BID CLARIFICATION #3

DUE DATE: May 21, 2015
TIME: 2:00 p.m.
PROJECT: North Eagleville Road Area Infrastructure Phase II
PROJECT NO: #901954
LOCATION: University of Connecticut
Capital Projects & Contract Administration
3 North Hillside Road
Storrs, CT 06269
Attn: Walt Dalia

THIS ADDENDUM FORMS PART OF THE BIDDING DOCUMENTS FOR NORTH EAGLEVILLE ROAD AREA INFRASTRUCTURE REPAIR / REPLACEMENT AND UPGRADE PHASE II – YOUNG QUAD UTILITIES, AND MODIFIES THE ORIGINAL BIDDING DOCUMENTS THAT ARE DATED APRIL 21, 2015.

C-01

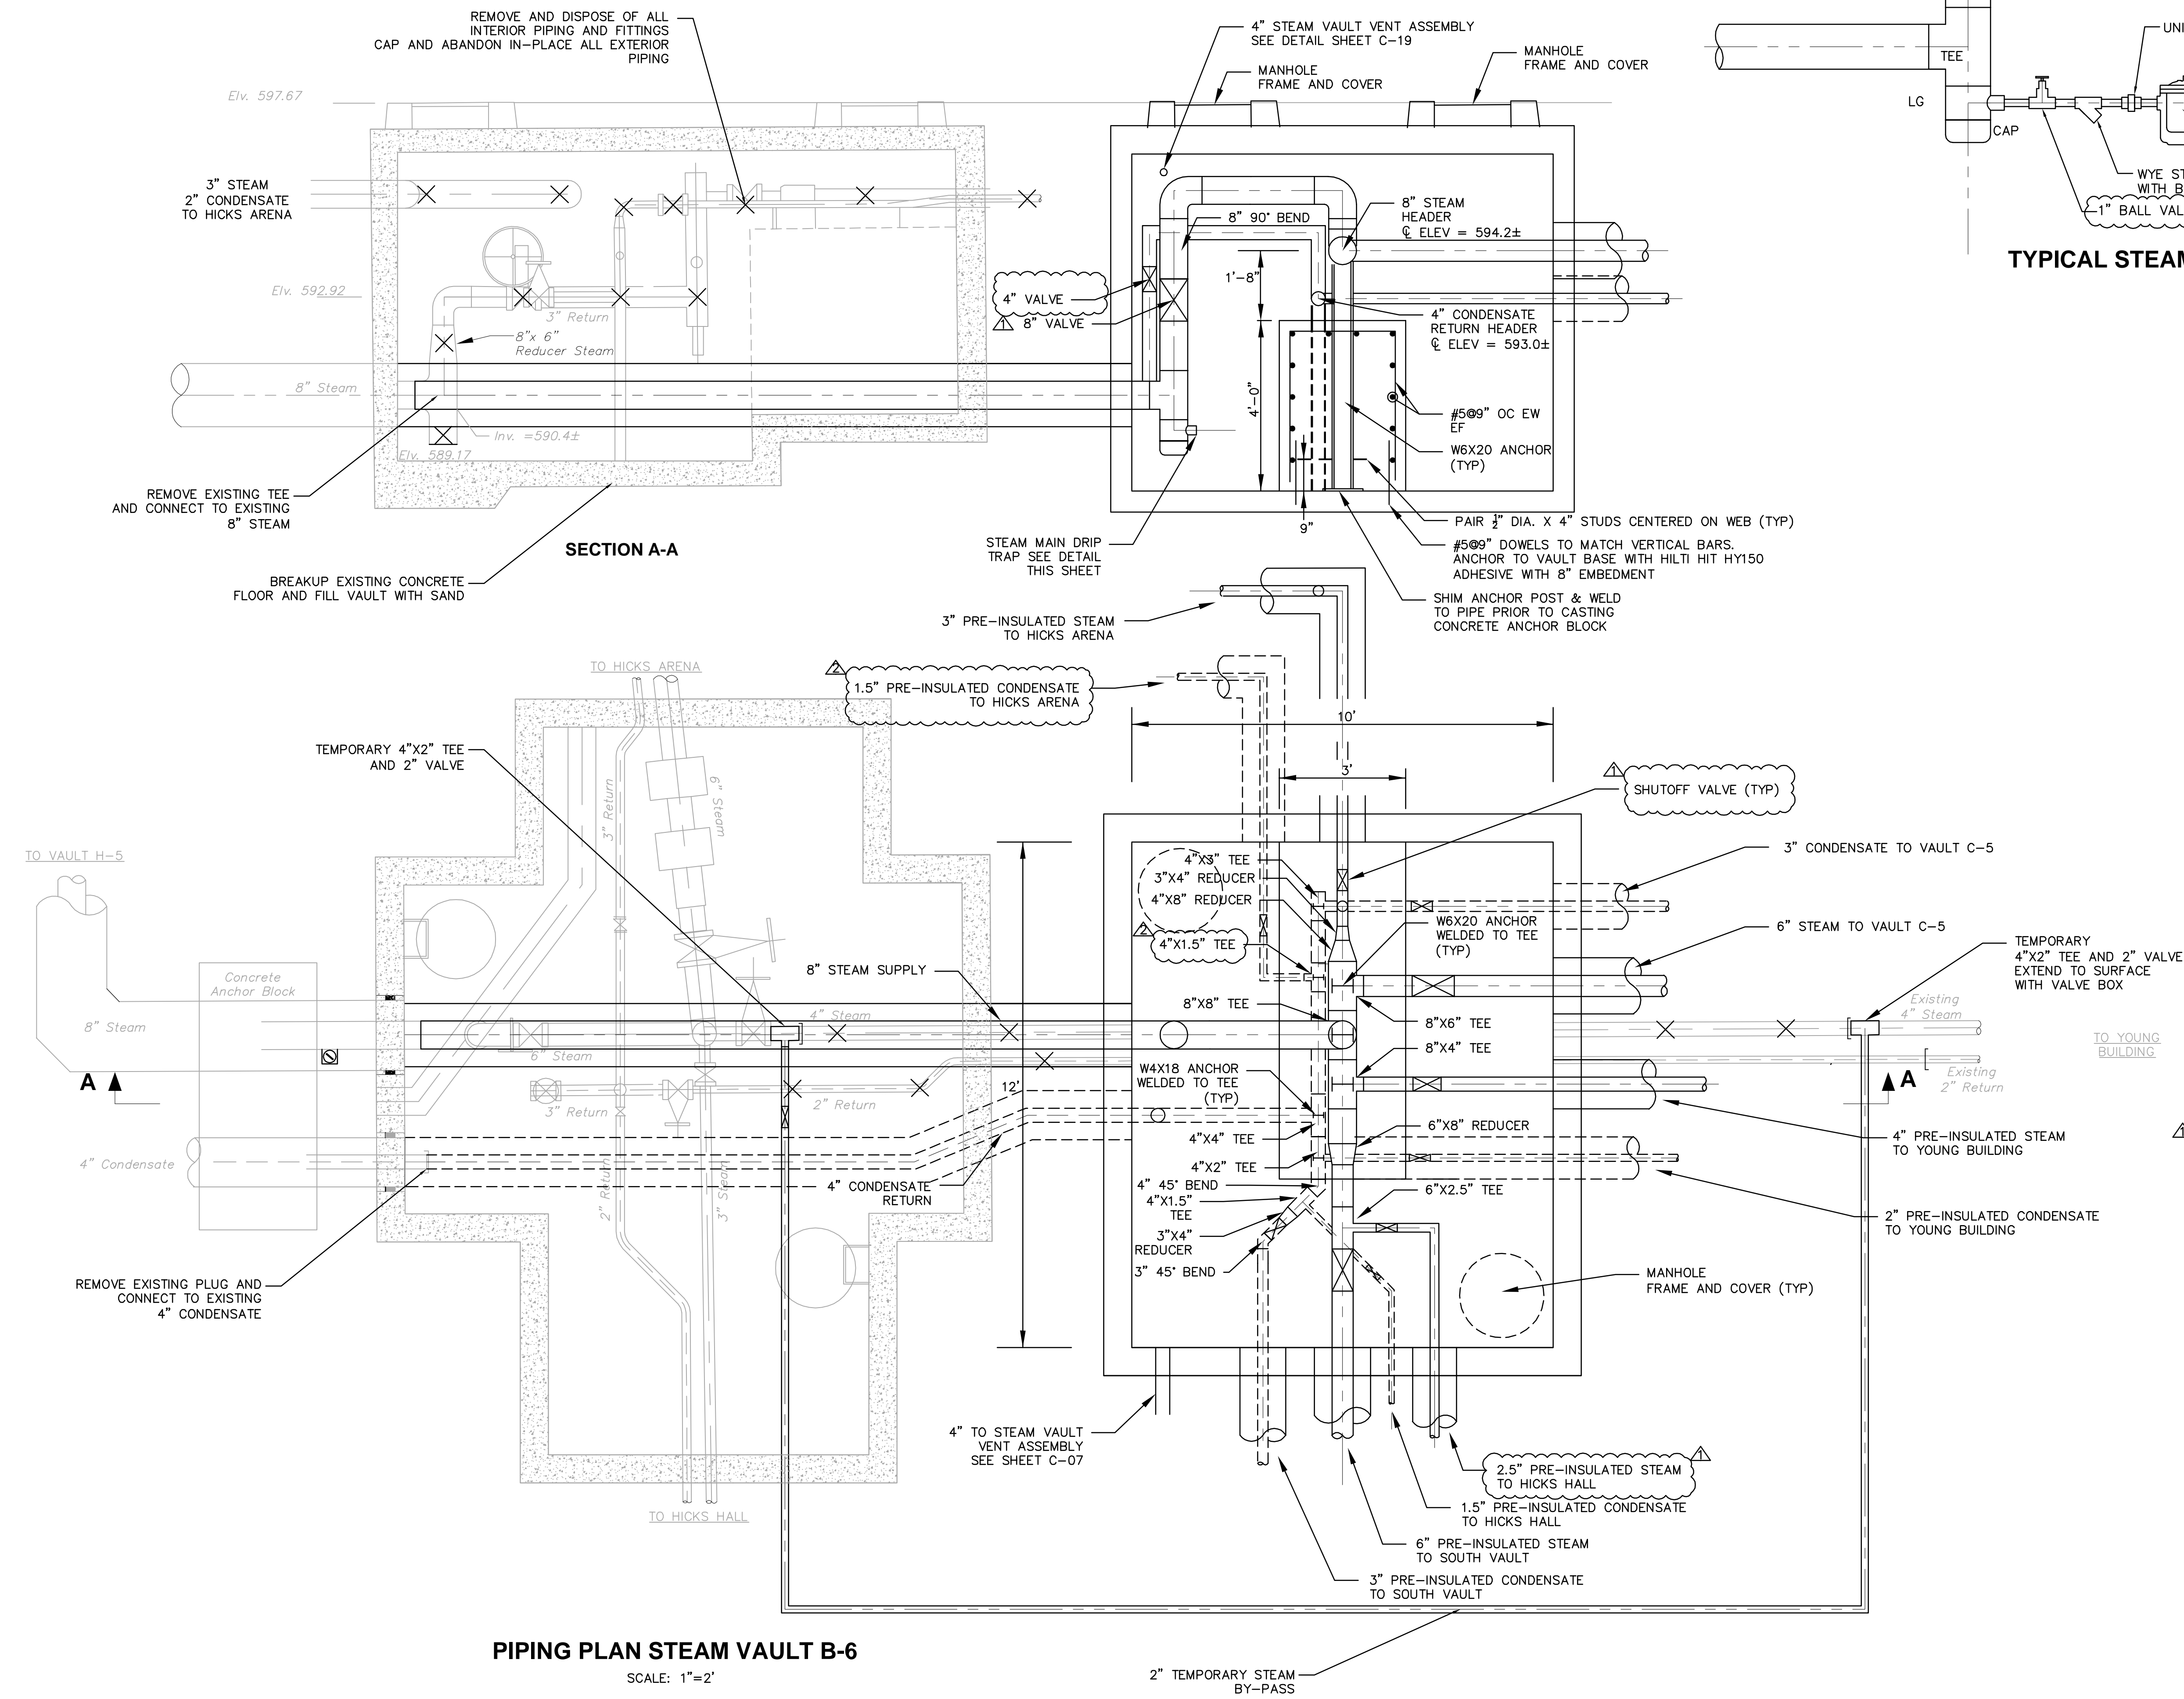
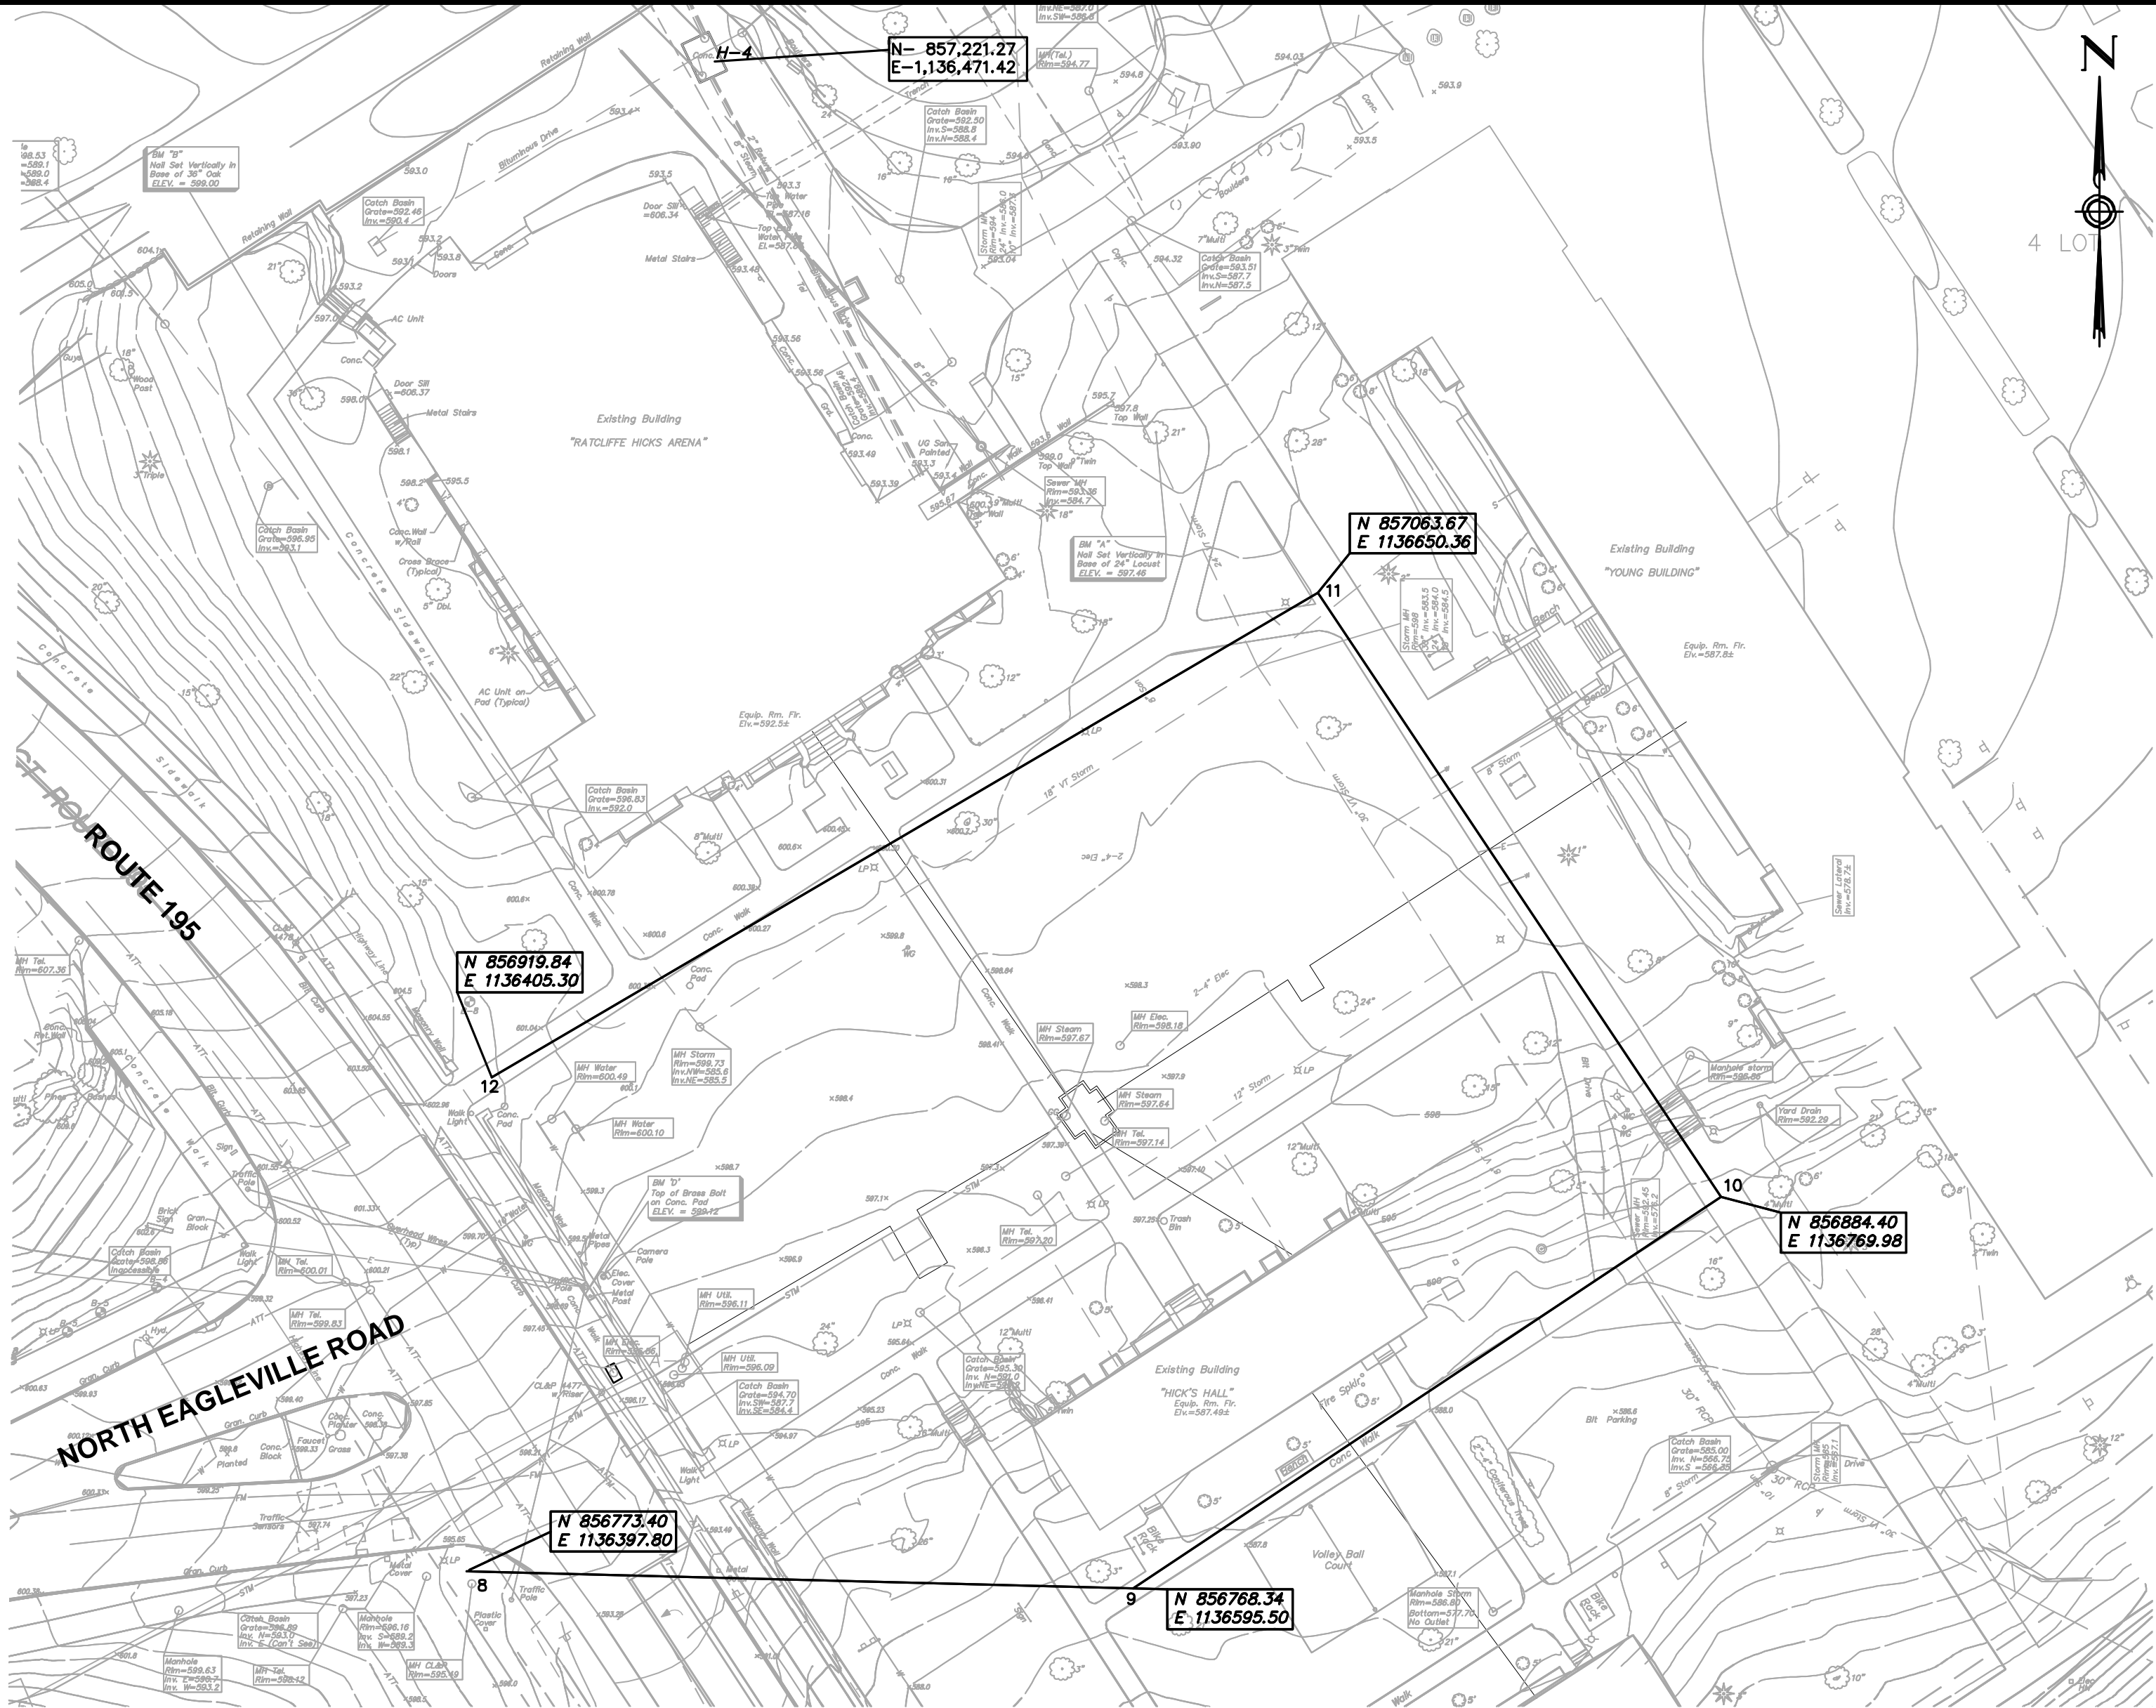
Sheet C-01

- ADDED: General Note to read “27. All piping installed by the contractor inside all buildings and all vaults shall be insulated in accordance with specification section 15082”.

27. ALL PIPING INSTALLED BY THE CONTRACTOR INSIDE ALL BUILDINGS AND ALL VAULTS SHALL BE INSULATED IN ACCORDANCE WITH SPECIFICATION SECTION 15082.

C-22

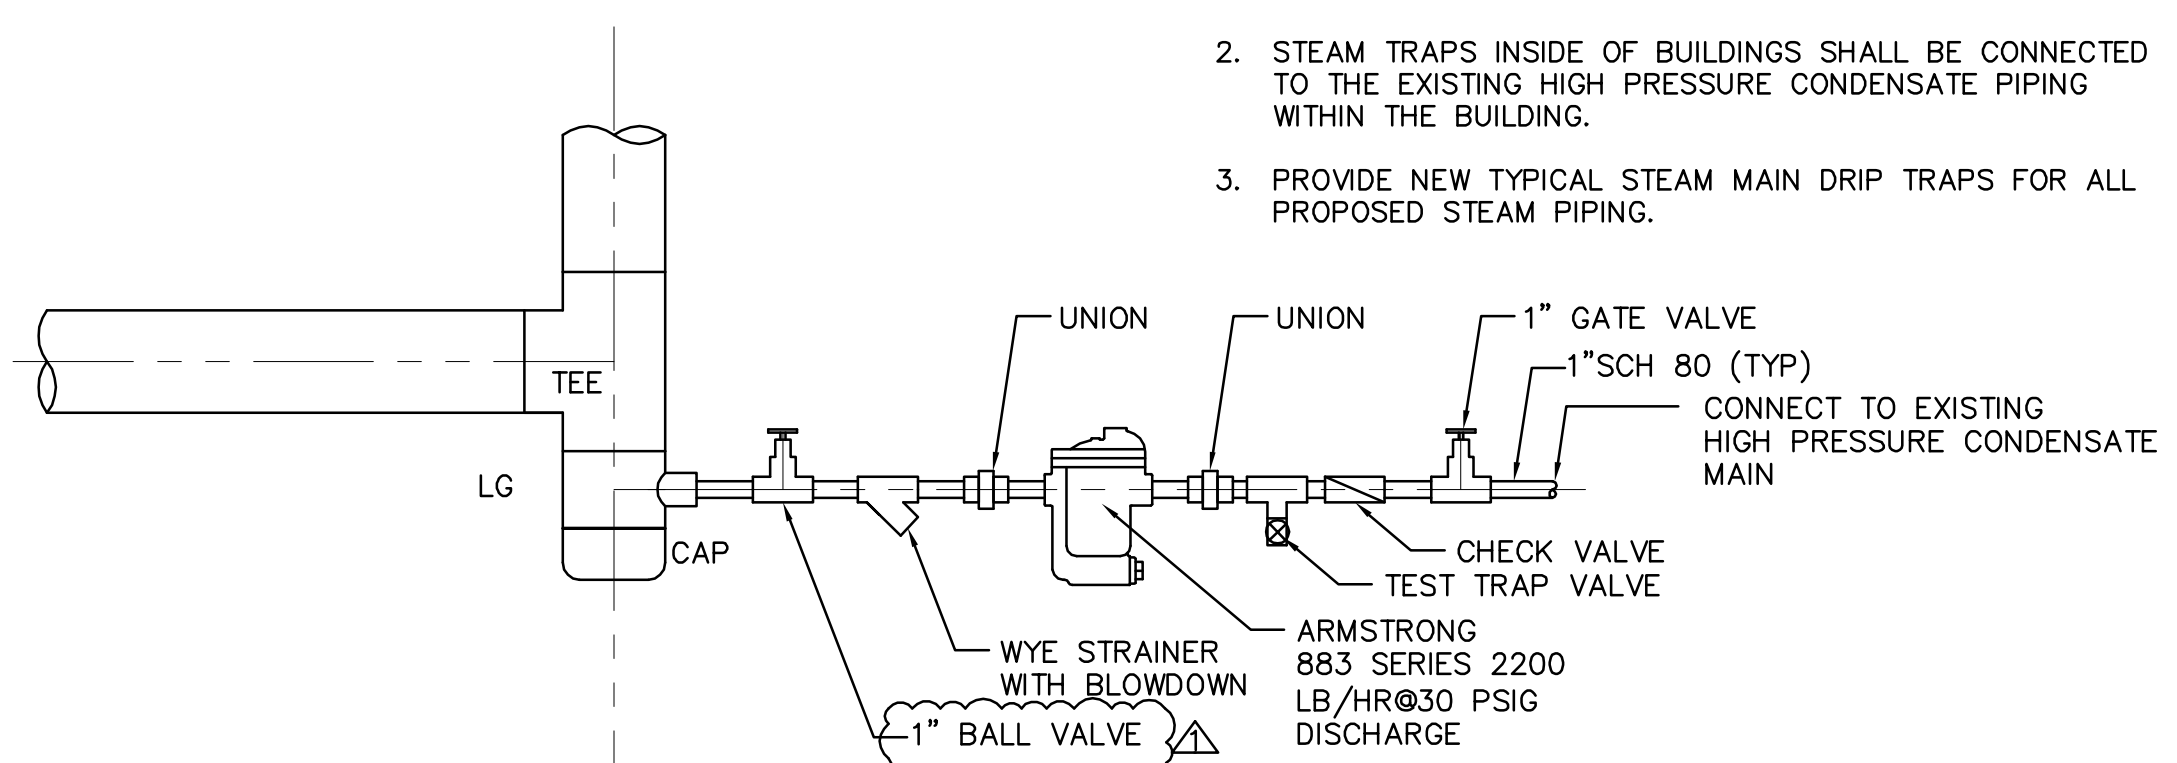
Sheet C-22

- REVISED: call out to read “1.5” Pre-insulated Condensate to Hicks Arena”
- REVISED: call out to read “4”x1.5” Tee”
